CITY OF CODY  
PLANNING, ZONING AND ADJUSTMENT BOARD  
TUESDAY, FEBRUARY 26 2013  
CITY HALL COUNCIL CHAMBERS @ 12:00 NOON

**CITY OF CODY  
PLANNING, ZONING AND ADJUSTMENT BOARD  
STAFF REPORT**

<b>MEETING DATE:</b>	FEBRUARY 26, 2013	<b>TYPE OF ACTION NEEDED</b>	
<b>AGENDA ITEM:</b>		P&Z BOARD APPROVAL:	X
<b>SUBJECT:</b>	CHAMBERLIN INN CONSERVATORY, DOWNTOWN ARCHITECTURAL DISTRICT REVIEW SPR 2013-03	RECOMMENDATION TO COUNCIL:	
<b>PREPARED BY:</b>	TODD STOWELL, CITY PLANNER	DISCUSSION ONLY:

<b>MEETING DATE:</b>	FEBRUARY 26, 2013	<b>TYPE OF ACTION NEEDED</b>	
<b>AGENDA ITEM:</b>		P&Z BOARD APPROVAL:	X
<b>SUBJECT:</b>	SITE PLAN REVIEW: BAKER HUGHES ADDITION SPR 2013-07	RECOMMENDATION TO COUNCIL:	
<b>PREPARED BY:</b>	TODD STOWELL, CITY PLANNER	DISCUSSION ONLY:

**DRAINAGE PLAN  
BUILDING ADDITION**

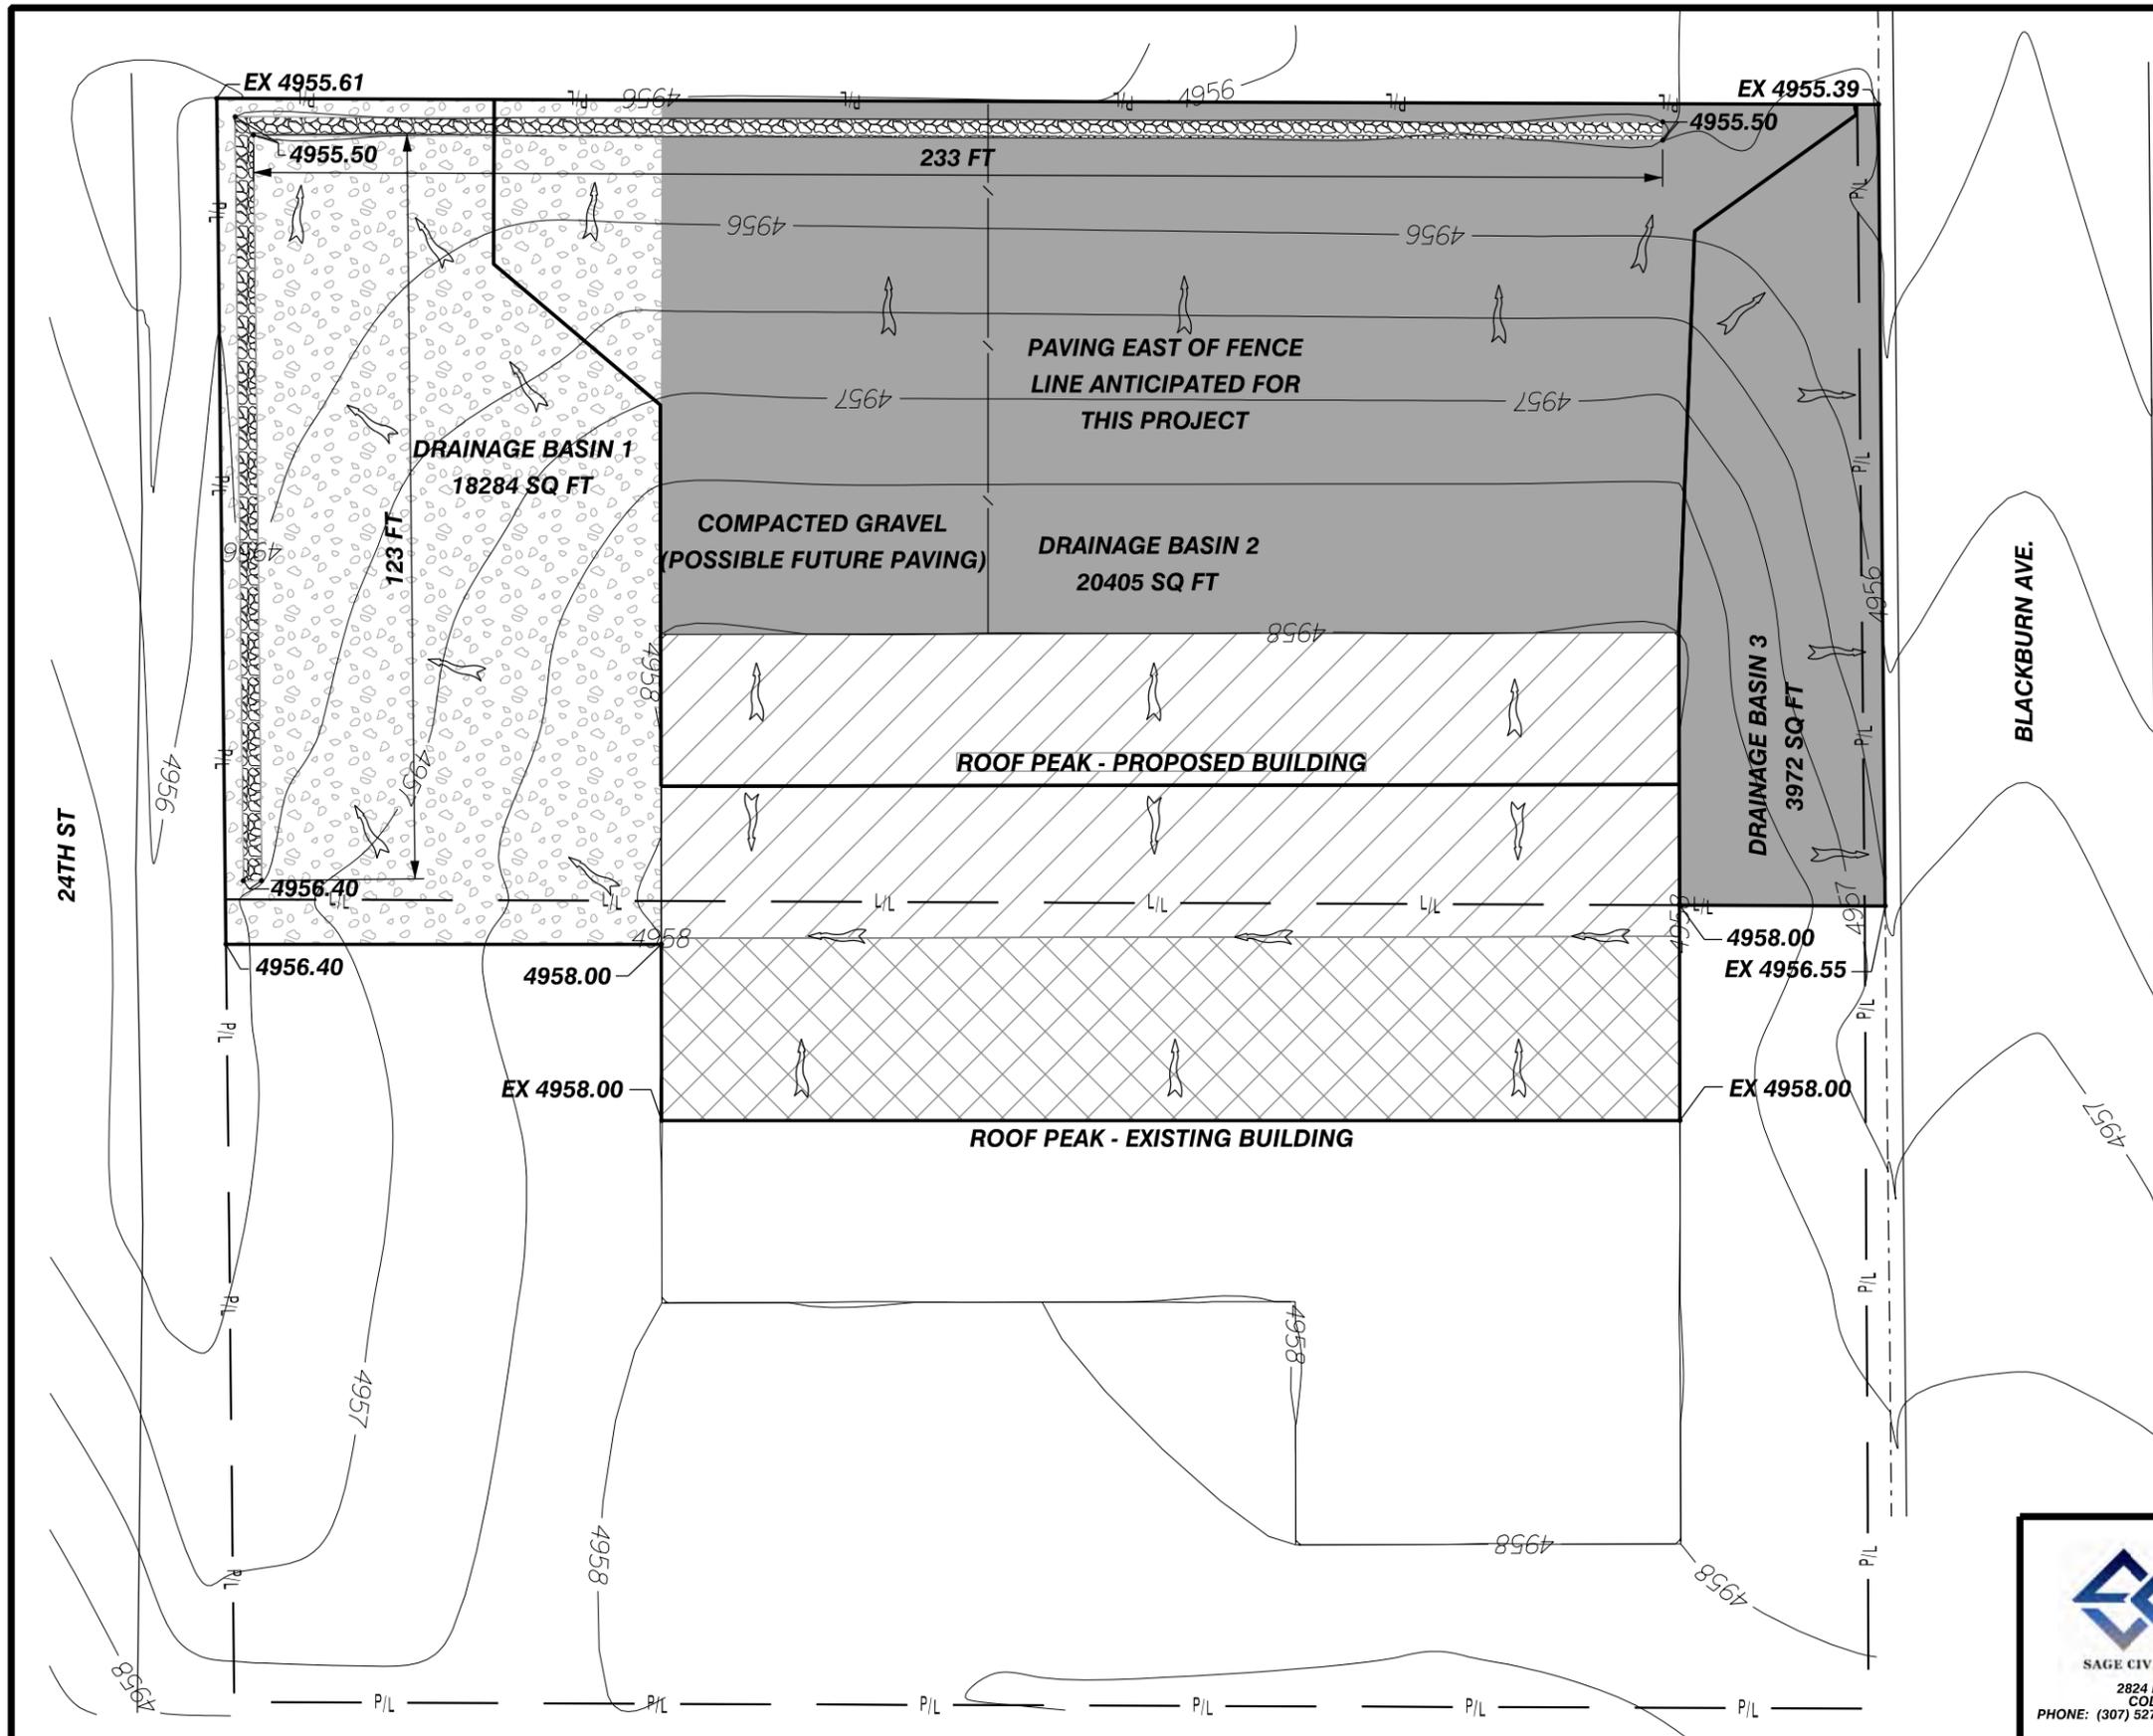
An engineered storm water plan has been prepared to address runoff according to the City's storm water policy manual. The roof drainage will be collected through a gutter system and sent to infiltration trenches along the north and west property lines. The infiltration trenches will be filled with cobble so that their surface is at ground level.

The south half of the roof for the proposed addition and the north half of the existing building are sloped towards each other. The Building Official and City Engineer are somewhat concerned about the lack of details for how the proposed gutter system will function to carry all roof storm water the full 168 feet to the west end of the building. Running the roof water to the east will not work with the proposed grading of the site and still meet storm water runoff requirements. Details of the gutter system will need to be provided with the building permit application.

1. That details of the roof drainage be submitted no later than at the time of building permit review, for approval by the Building Official and City Engineer upon demonstration that storm water from the middle of the roof will flow to the west as proposed, or otherwise be directed to the infiltration trench.
2. That prior to issuance of a building permit, the lot line must be removed or relocated.
3. That the storm water facilities be inspected and certified by the applicant's engineer prior to building occupancy.
4. That any exterior lighting be of a down-lit style.
5. That a second ADA parking space and loading area be provided in accordance with ADA standards.
6. That the project must otherwise comply with the submitted site plan and applicable building, fire, and electrical codes. A building permit application is required.
